**CITY OF RANCHO MIRAGE**

**CITY OF RANCHO MIRAGE  
ADDENDUM NO. 1**

**Bob Hope Drive and Frank Sinatra Drive  
Intersection Improvement  
PROJECT NO. C.P. 12-270-1**

| NOTIFICATION#                   | DUE DATE   | VOLTAGE DROP: 1.22<br>FLICKER FACTOR: N/A  | DESIGN/DRWG NO.<br>779420-0.01     |

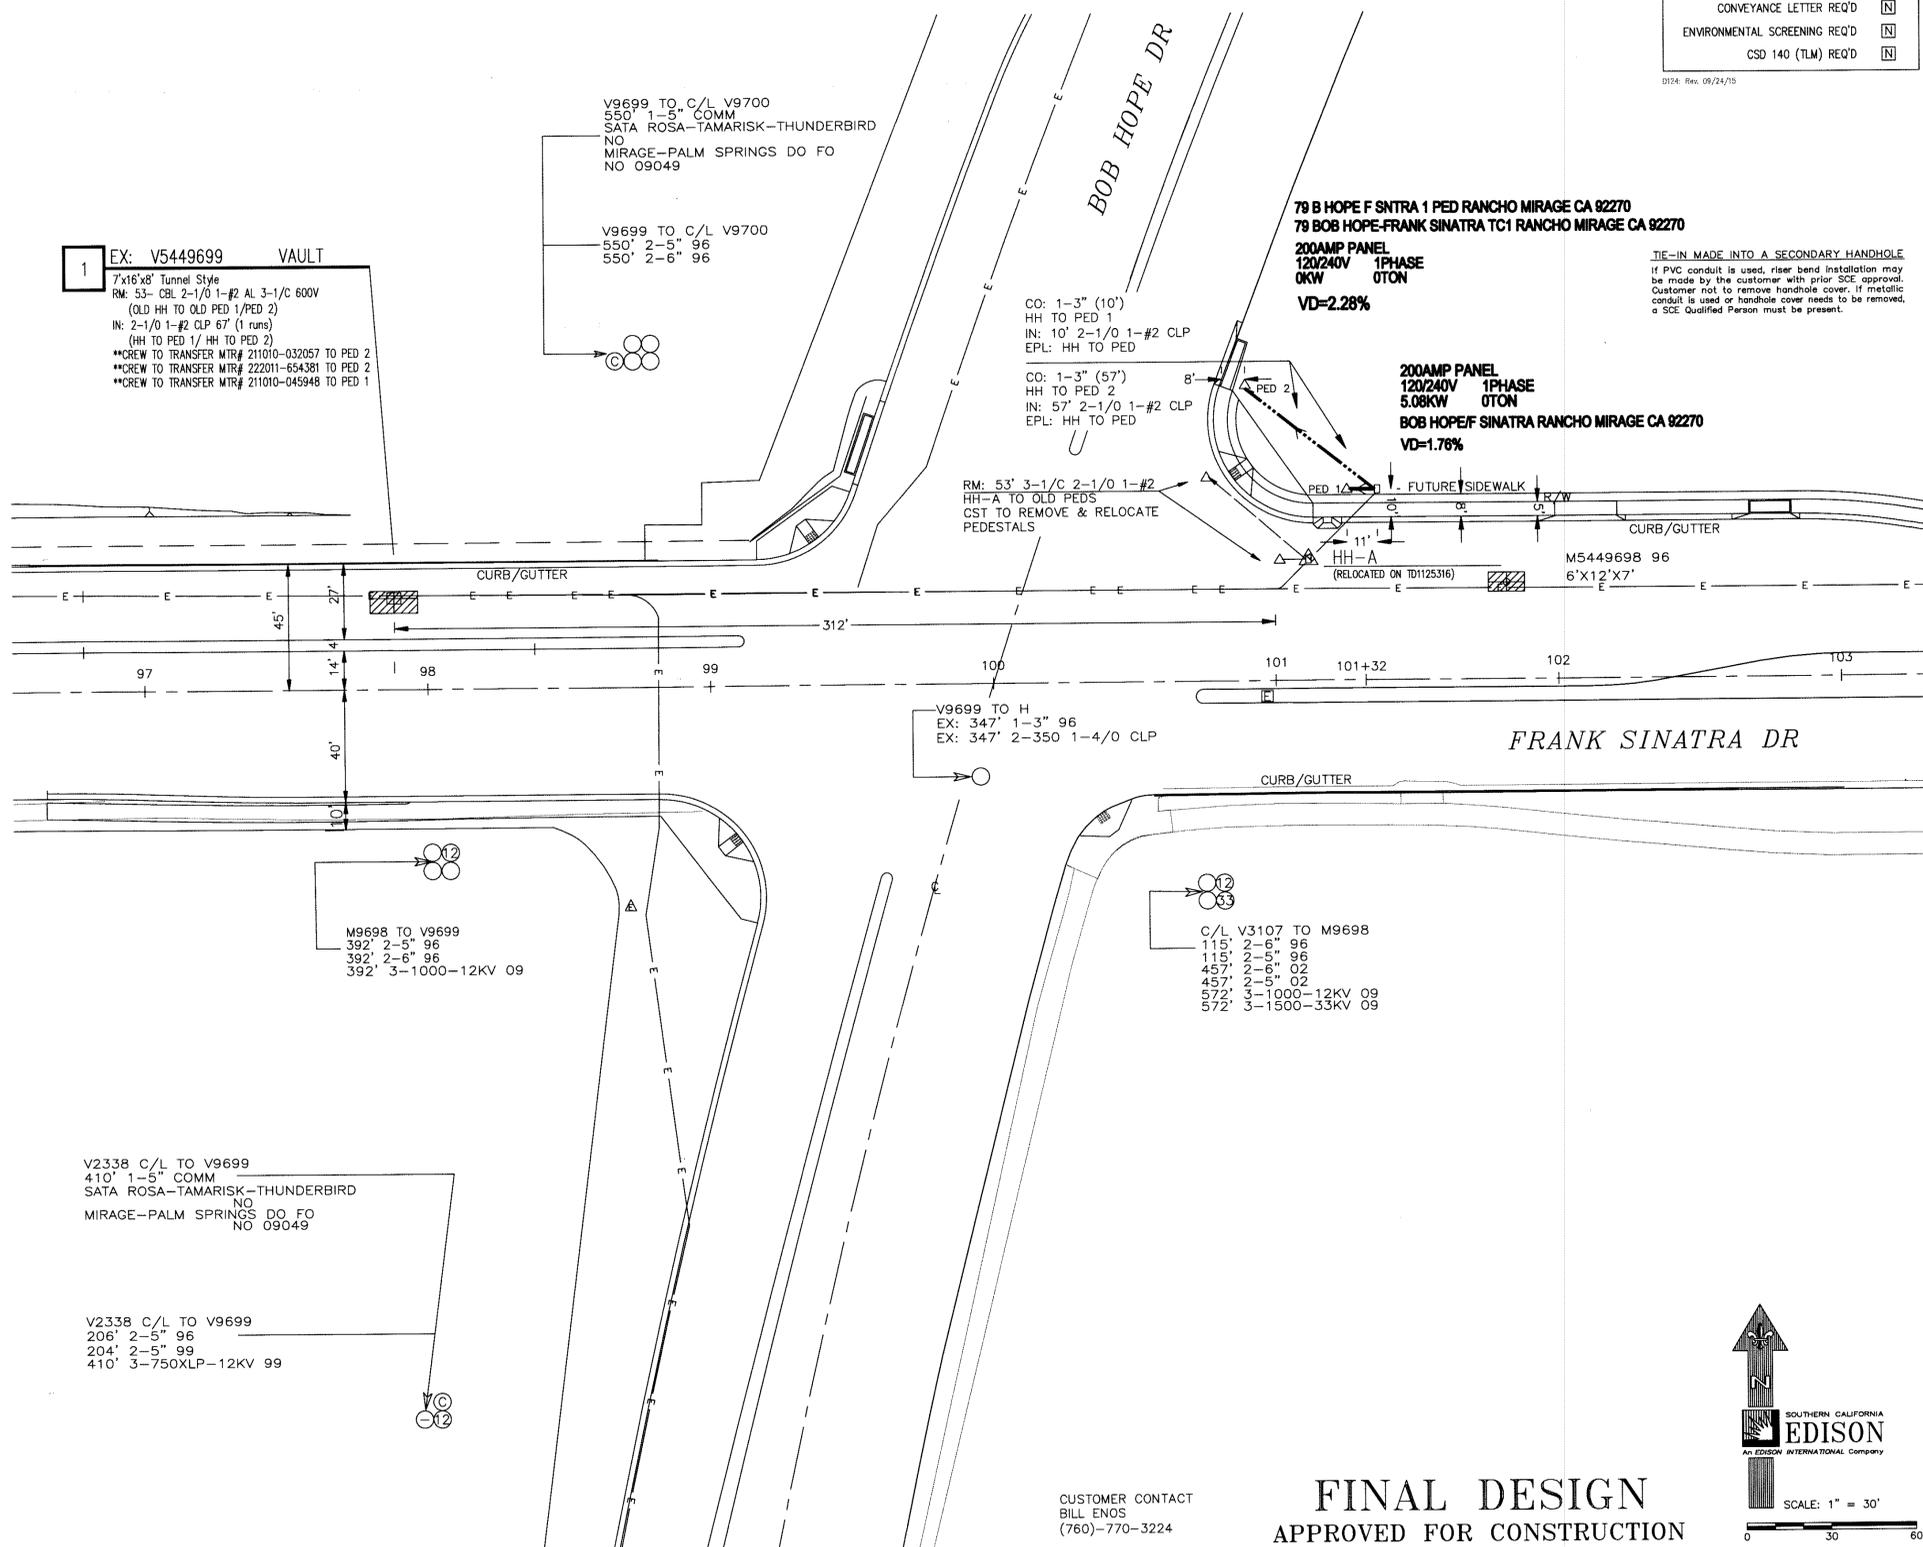
1. Under PROJECT PLANS, Replace SCE Drawing 779420\_0.01 "PRELIMINARY – Not For Construction" with attached SCE Drawing 779420\_0.01 "FINAL DESIGN – APPROVED FOR CONSTRUCTION"; Customer Installed work shown on the plan to be constructed by Contractor and payment for work shall be included in Bid Item 39. Traffic Signal Modification per Plan Complete in Place, and no additional payment will be made therefor.
2. Under PROJECT SPECIFICATIONS, Special Provisions, Page 00800-SP-23, **Section 302-5.8, Manholes (and other structures)**, Modify the first sentence to read "All water valve covers and manhole covers shall be lowered by the Contractor prior to paving, and will be raised after paving is completed by **Contractor per Coachella Valley Water District standards.**"
